Rezoning Transportation Analysis

Petition Number: 2022-155

Date	Description
1-25-23	First Review (TM)
2-23-23	Second Review (TM)

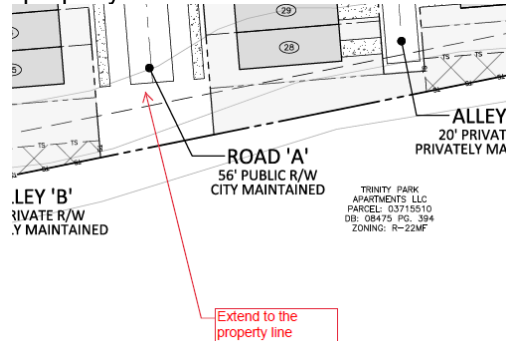
5. **Outstanding Comment from 01-25-23:** Add a conditional note specifying "A Right-of-Way Encroachment Agreement is required for the installation of any non-standard item(s) (irrigation systems, decorative concrete pavement, brick pavers, etc.) within a proposed/existing City-maintained street right-of-way by a private individual, group, business, or homeowner's/business association. An encroachment agreement must be approved by CDOT prior to construction/installation. Contact CDOT for additional information concerning cost, submittal, and liability insurance coverage requirements."

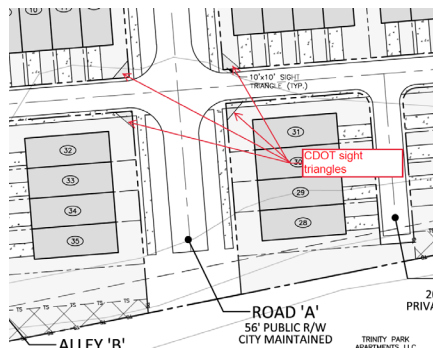
8. ~~Revise site plan and conditional note(s) to commit to clearly identifying Road A as standard from the CLDSM. Add standard to the callout of road A as well as add a conditional note committing to constructing roadway A to a CLDSM standard. Site plan shall label and dimension roadway infrastructure from the roadway centerline including ROW.~~
9. ~~Revise site plan and conditional note(s) to commit to clearly identifying Alley cross sections as a standard from the CLDSM. Add standard to the callout of alleyways as well as add a conditional note committing to constructing them to CLDSM standard.~~
10. ~~Revise site plan by dimensioning the sidewalk along Alley A.~~
11. ~~Revise site plan by adding CDOT sight triangles to the intersection of Alley A and Roadway A per CDOT sight distance policy. Show either the 50 x 50 sight triangle or the 35 x 3 sight triangle.~~
